**SAAB**

SERVICE INFORMATION

SI No. 432-2024	Date November 1998	900
PI No.	Distr. all

Improved bush and gear linkage

D432B615

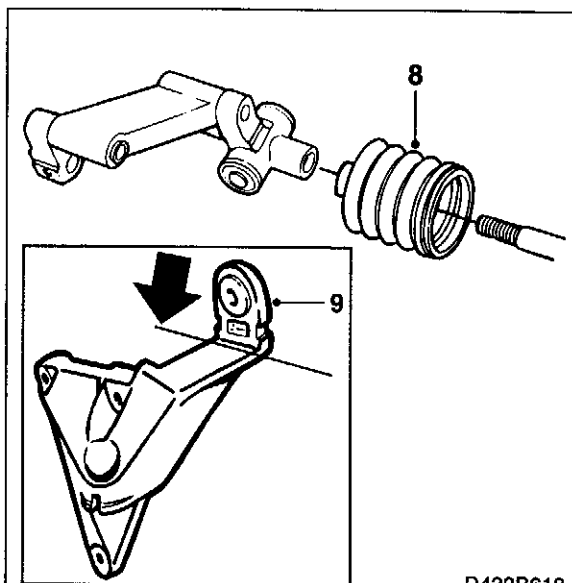
A problem may occur with the gear shifting on cer-tain cars that makes it difficult to change gear. This is caused by a bush connecting the front gear rod with the gear linkage breaking under stress. The problem has been especially evident on cars that have been driven hard and aggressively in warm climates.

The solution is to install an improved linkage assem-bly.

- 46 26 321 Linkage (CA: 30579660)
- 46 26 677 Ball stud (CA: 30564619)
- 46 26 537 Seal (CA: 30564607)

D432B618

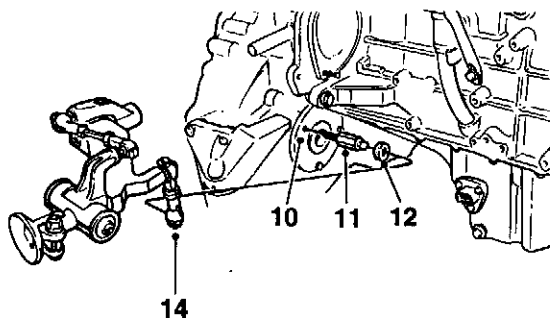
- 8 Remove the rubber boot above the "lug".
- 9 Saw off the "lug" containing the plastic bush in the rear engine mounting.
File off any burrs.

- 10 Remove the top rear screw on the seal retainer with Torx key 40.
- 11 Fit the ball stud into the screw hole.
Tightening torque: 22 Nm (16 lbf ft)
- 12 Fit the seal.
- 13 Position the new gear linkage on the gear rod in the gearbox.
- 14 Position the ball stud and apply the lock mechanism.
- 15 Lower the car
- 16 Screw together the gear linkage with the gear rod in the gearbox.
Tightening torque: 22 Nm (16 lbf ft)

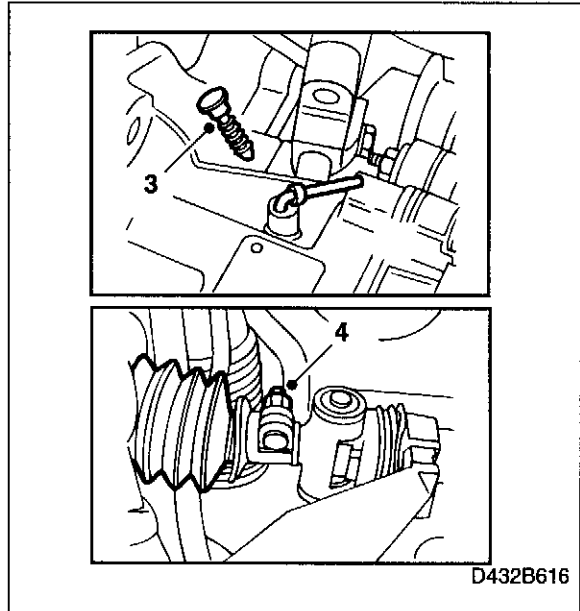
- 1 Place the car on a lift.
- 2 Engage 4th gear.
- 3 Remove the plastic plug on the gearbox and insert lock pin 87 92 335 (with the ring up) to lock the gearbox in 4th gear.
- 4 Undo the nut securing the gear rod to the linkage in the gearbox. Use a 13 mm spanner.

- 5 Move the gear lever to 3rd gear position so that the gear rod slides out of the linkage. Remove the screw securing the linkage to the gearbox.
- 6 Raise the car.
- 7 Remove the gear linkage.
